The Commission has issued the enclosed Amendments Nos. 73, 73 and 70 for Licenses Nos. DPR-38, DPR-47 and DPR-55 for the Oconee Nuclear Station, Units Nos. 1, 2 and 3. These amendments consist of changes to the Station's common Technical Specifications and are in response to your request dated March 30, 1979, as supplemented May 17, 1979.

These amendments revise the Technical Specifications to support the operation of Oconee Unit No. 3 at full rated power during Cycle 5. The amendments also revise the Technical Specifications for Units Nos. 1, 2 and 3 in regard to power level cut-off.

AMENDMENT TO FACILITY OPERATING LICENSE

ATTACHMENTS TO LICENSE AMENDMENTS

CORE PROTECTION SAFETY LIMITS
UNIT 3
OCONEE NUCLEAR STATION
Figure 2.1-2C

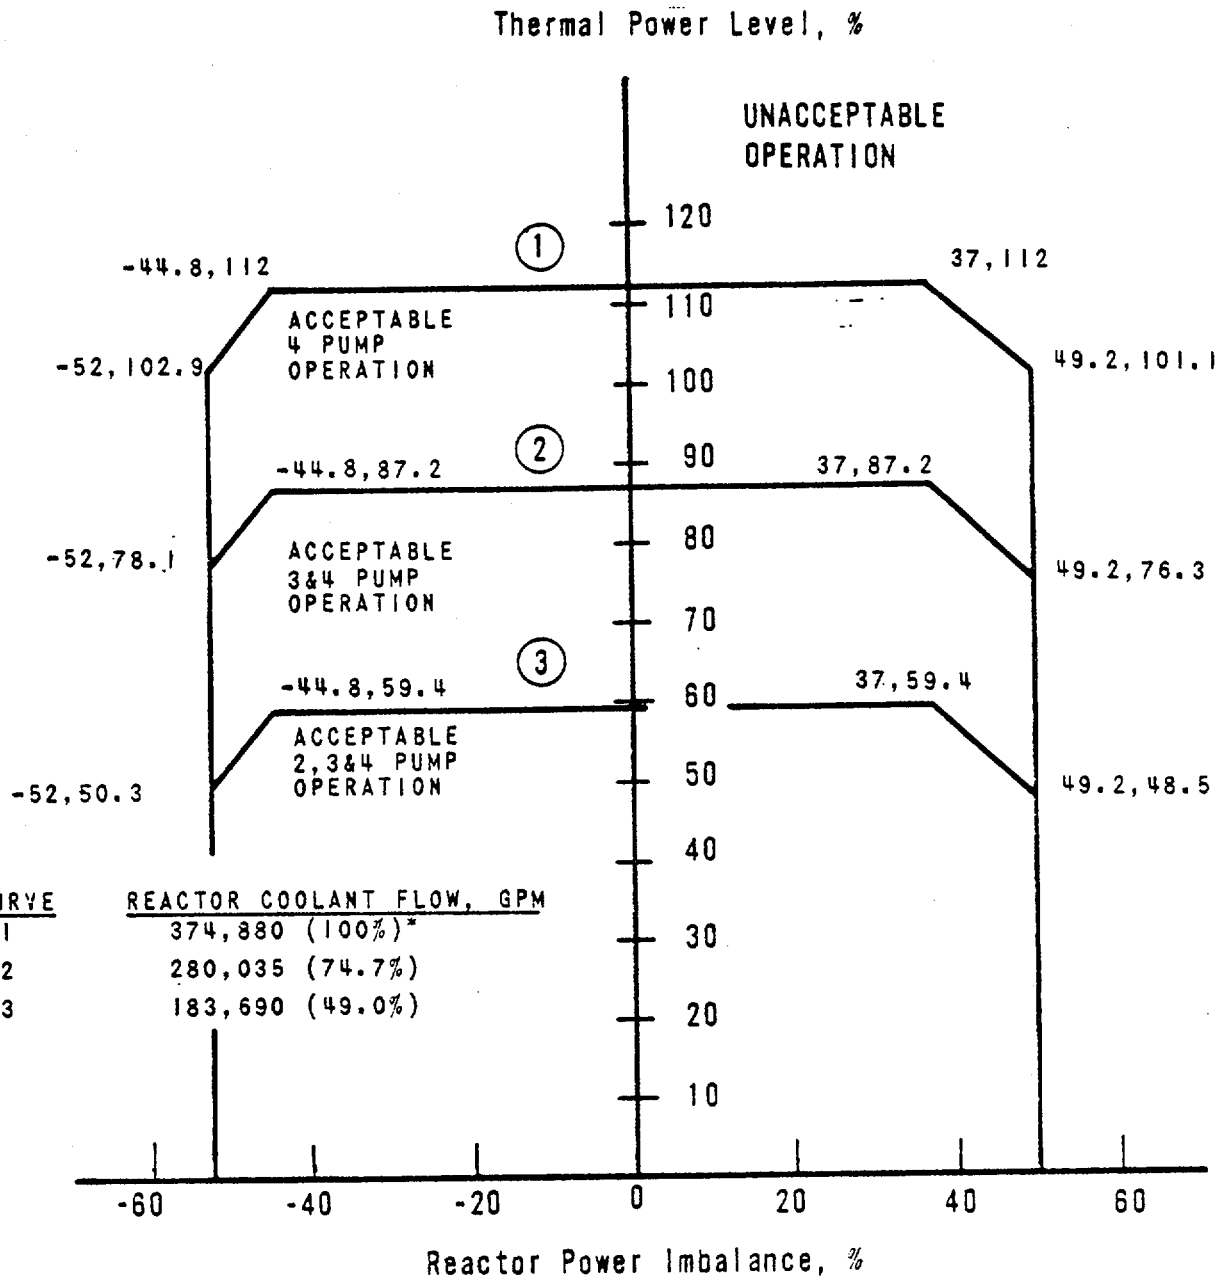
The specified flow rates for Curves 1, 2 and 3 of Figure 2.1-2C correspond to the expected minimum flow rates with four pumps, three pumps and one pump in each loop, respectively.

The maximum thermal power for three-pump operation is 87.2 percent due to a power level trip produced by the flux-flow ratio 74.7 percent flow x 1.08 = 80.7 percent power plus the maximum calibration and instrument error (Reference 4). The maximum thermal power for other coolant pump conditions are produced in a similar manner.

CURVE	REACTOR COOLANT FLOW, GPM
1	374,880 (100%)*
2	280,035 (74.7%)
3	183,690 (49.0%)

PROTECTIVE SYSTEM
MAXIMUM ALLOWABLE SETPOINTS
UNIT 3
OCONEE NUCLEAR STATION
Figure 2.3-2C

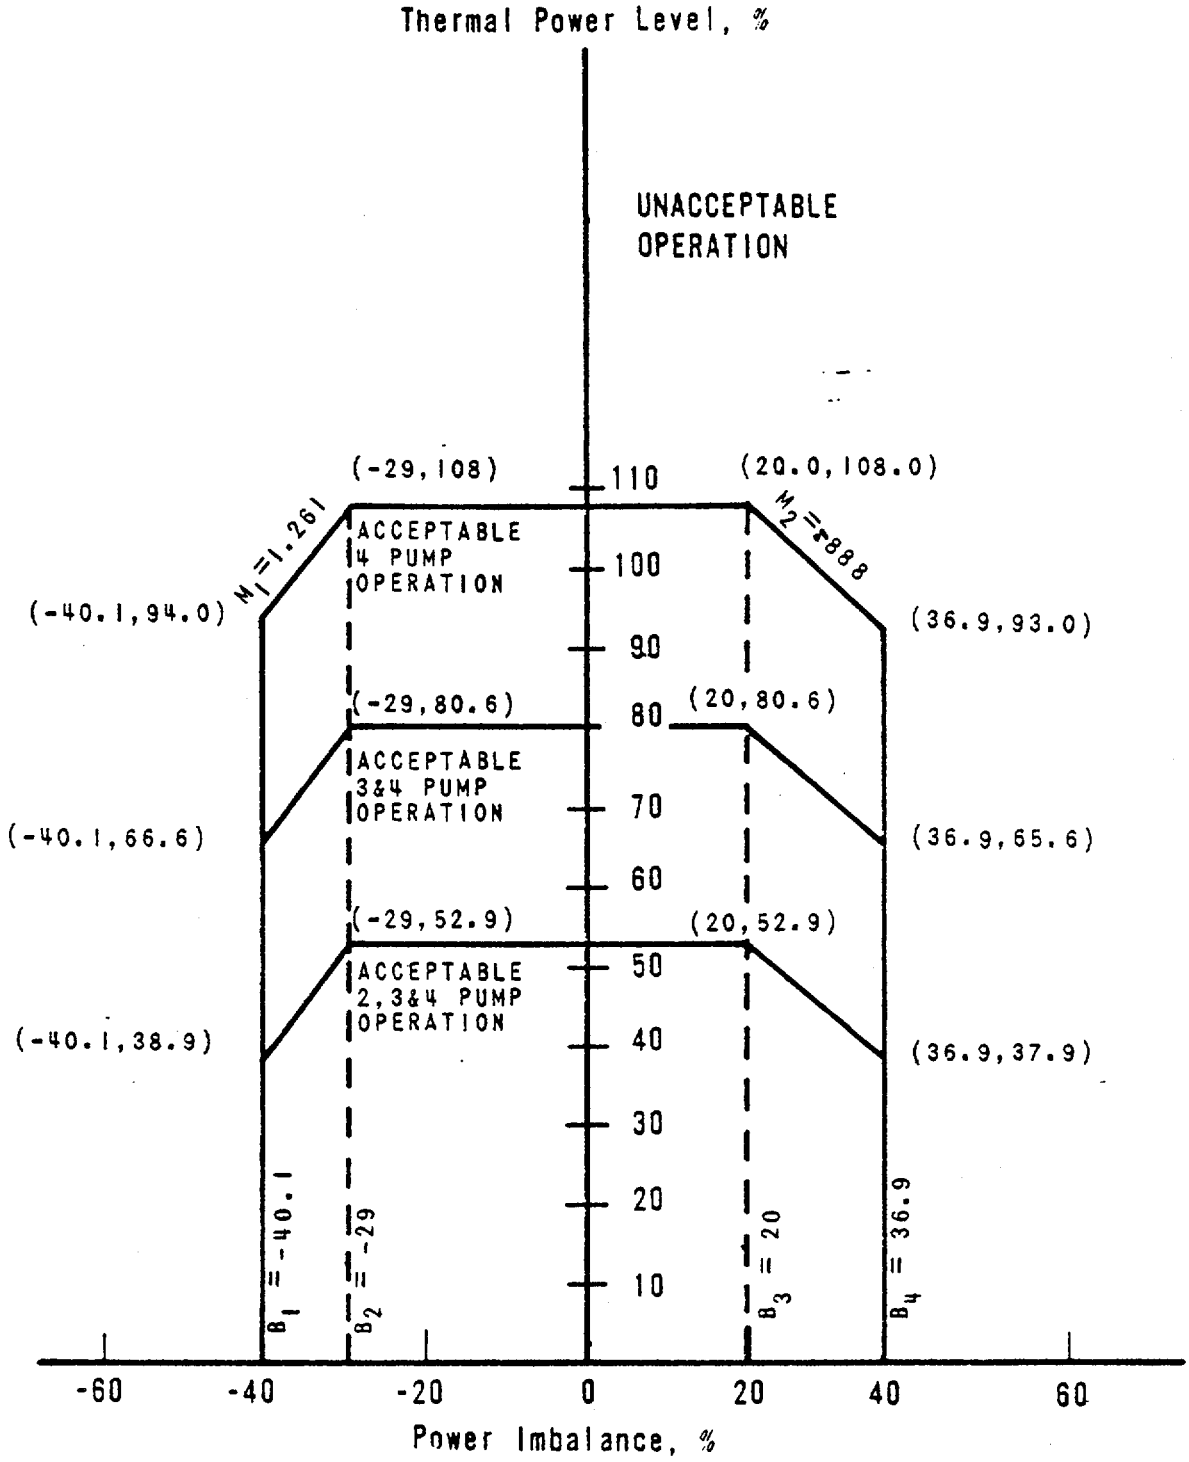
The low pressure (1800) psig and variable low pressure (11.14 T_{out}-4706) trip
(1800) psig (11.14 T_{out}-4706)
(1800) psig (11.14 T_{out}-4706)
setpoints shown in Figure 2.3-1A have been established to maintain the DNB
2.3-1B
2.3-1C
ratio greater than or equal to 1.3 for those design accidents that result in a pressure reduction. (2,3)

The high reactor coolant outlet temperature trip setting limit (619°F) shown in Figure 2.3-1A has been established to prevent excessive core coolant
2.3-1B
2.3-1C
temperatures in the operating range. Due to calibration and instrumentation errors, the safety analysis used a trip setpoint of 620°F.
